Subject: AP1000 Response to Request for Additional Information (SRP TR03)

AP1000 TECHNICAL REPORT REVIEW

RAI Response Number: RAI-TR03-022

RAI Response Number: RAI-TR03-037
Revision: 3

Figure RAI-TR03-022-01 – Comparison of Time History Displacements using Double Integration and Fast Fourier Transforms

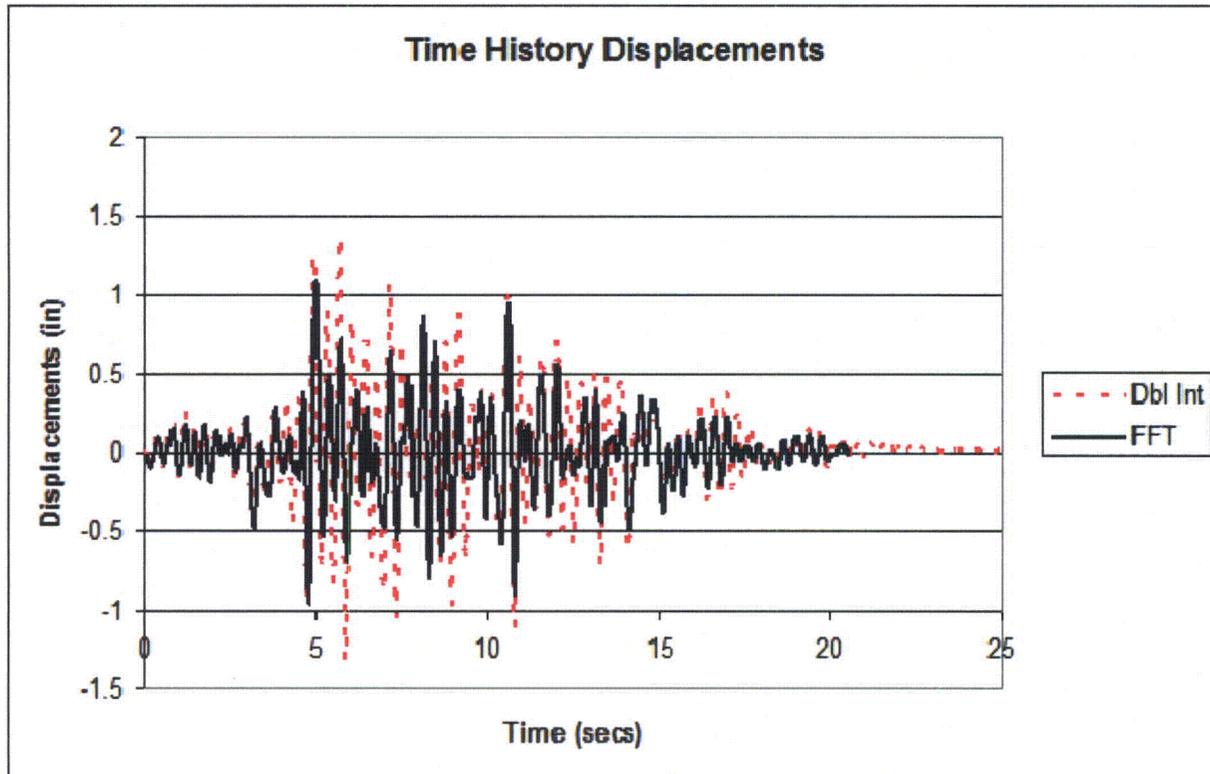
Section 6.3 states "The maximum seismic deflections that were obtained from the time history analyses and SASSI analyses given in Tables 6.3-1 to 6.3-3 for the auxiliary and shield building, containment internal structure, and steel containment vessel." For the staff to properly evaluate this information, the following additional information is needed:

- a. Are the deflections in the tables a consistent set, based on the worst-case time history result, or are they an envelope of maximum deflections from all the time history results?
- b. How do these tabulated deflections compare to the corresponding deflections obtained from the equivalent static acceleration analyses? Please provide a tabulated comparison, and an explanation of any significant differences.

- a. During the October 8-12, 2007 audit, the NRC requested that Westinghouse consider adjusting the deflections obtained from SSI analyses for drift in the frequency domain, and not use a baseline correction that subtracts the slope of the relative displacement multiplied by the time from the relative displacement at each time step. Westinghouse has adopted the recommended approach by calculating displacements internally within the SASSI program based on an analytical complex frequency domain approach that uses inverse fast-fourier transforms (FFT) to compute relative displacement histories

In Figure RAI-TR03-022-01 is presented a comparison for the baseline double integration (old, Dbl Int) method compared to the FFT (new method) shown for the soft to medium soil case at the top of the shield building.

**Figure 3G.4-5X:X Direction FRS for Node 130401 (NI10) or 1761 (NI20)
CIS at Reactor Vessel Support Elevation of 100'**

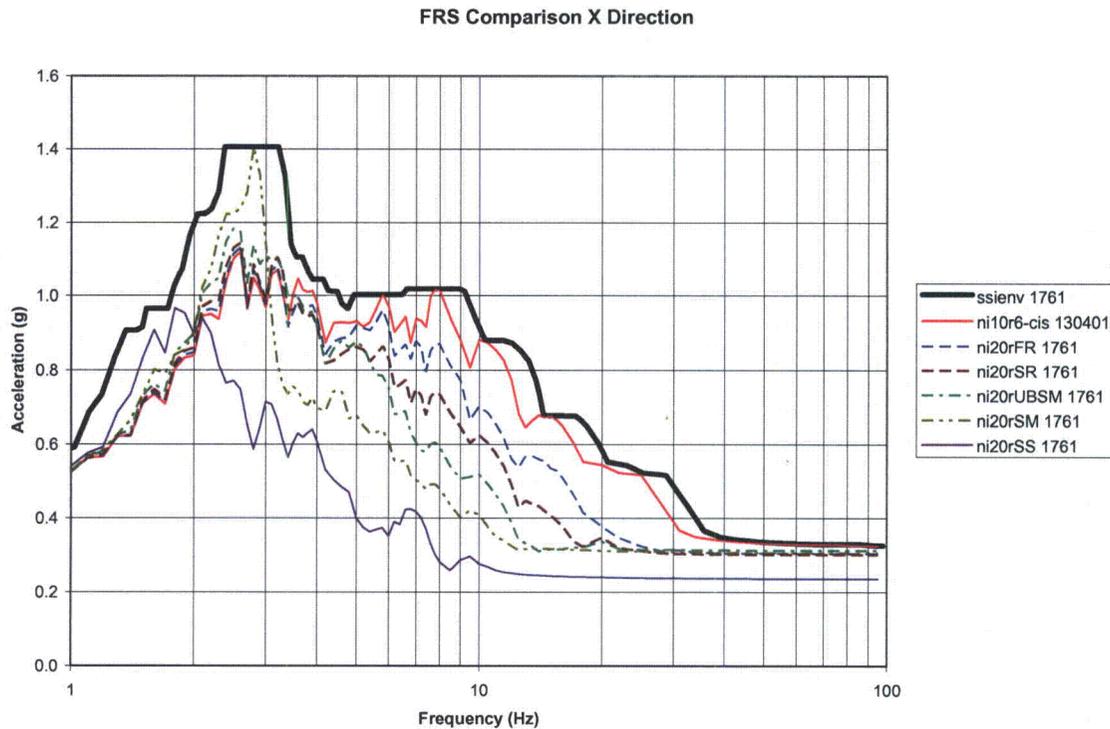
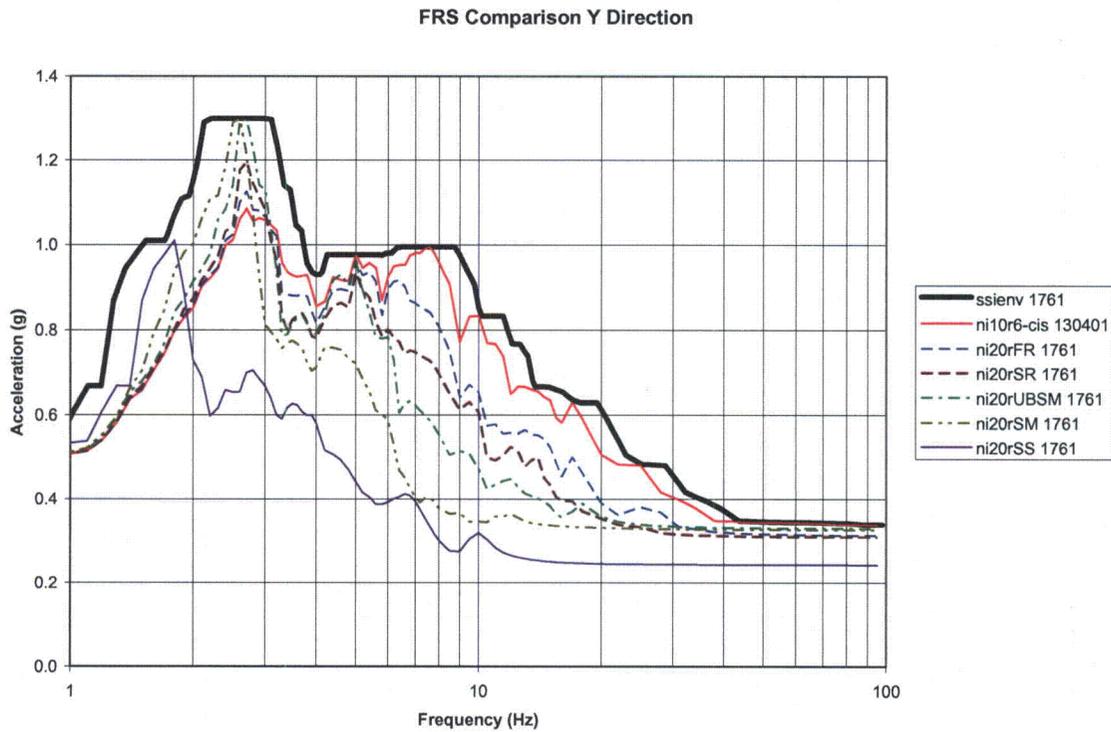
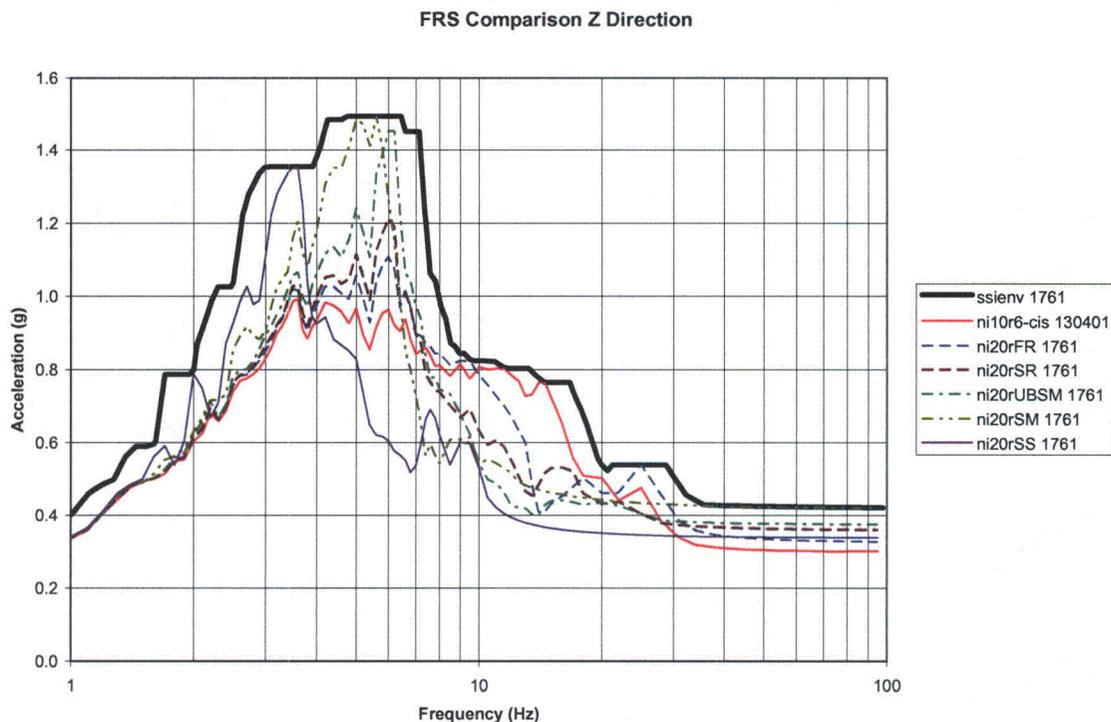
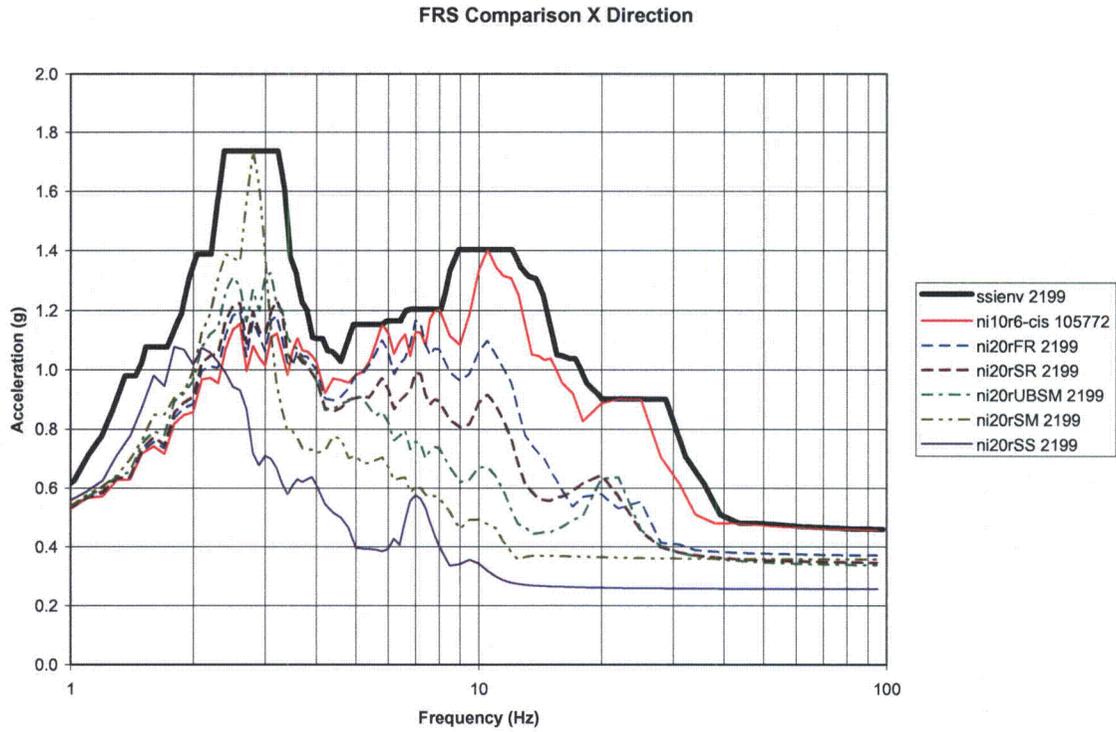
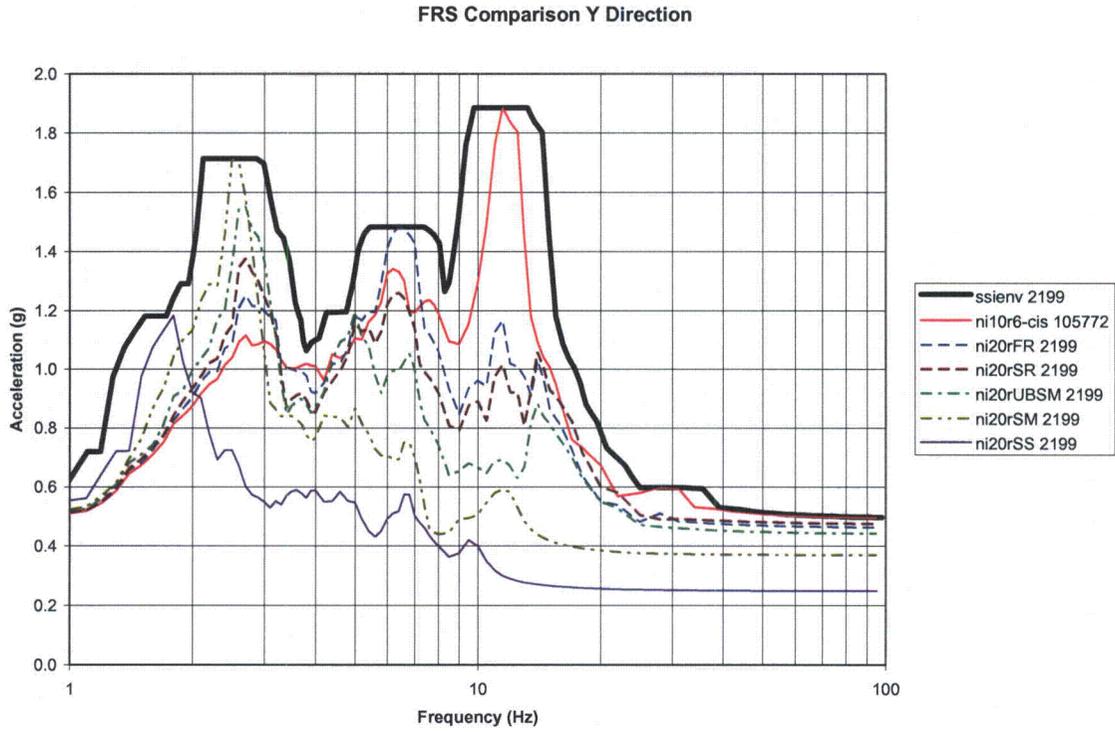
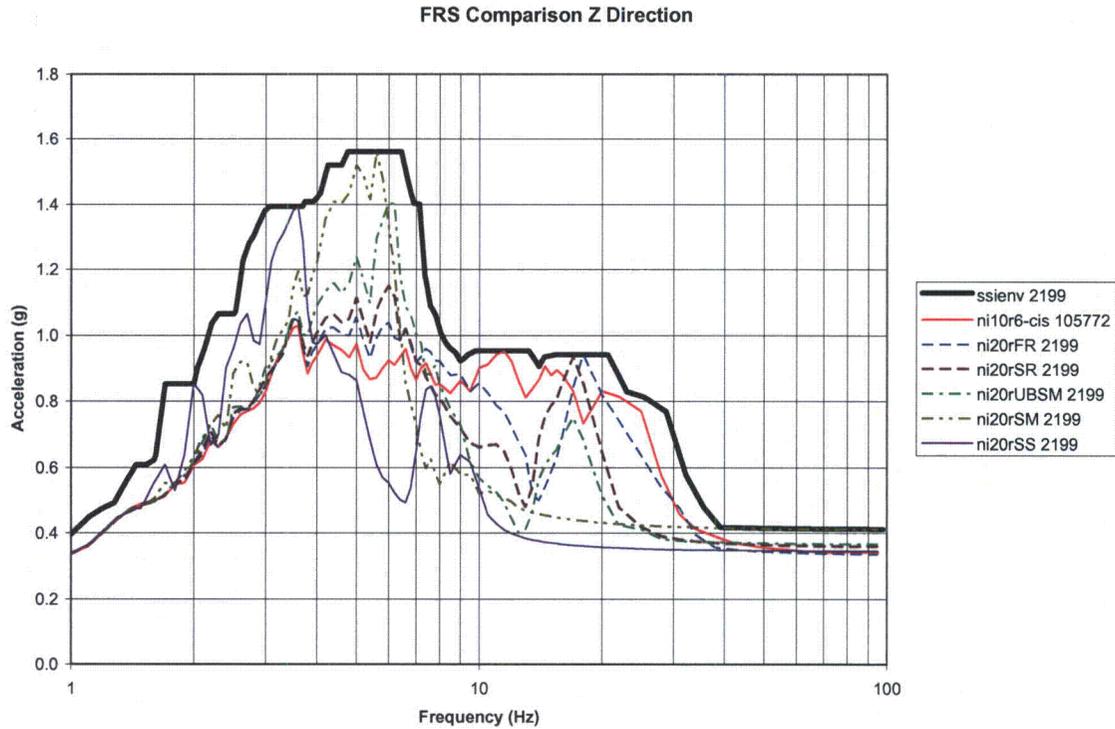
In TR-03, Revision 4, Section 4.4.1.2, the applicant added a new soil case for the deep soil site, and indicated that the deep soil site profile uses a unique input time history that is only used to develop in-structure design response spectra. The staff is unclear about how applicant would include this case as part of the seismic design basis. In TR-03, the deep soil site is not fully characterized nor is it clear regarding how the SSI analysis was performed using the CSDRS as the ground motion input. Therefore, the staff requests the applicant to provide a detailed description of the deep soil site condition, and provide the SSI results and justification for its application to the AP1000 design response spectra (CSDRS).

- Appendix E – Remove the deep soil case from Figures 3G.4-5X to 3G.4-10Z as shown below:
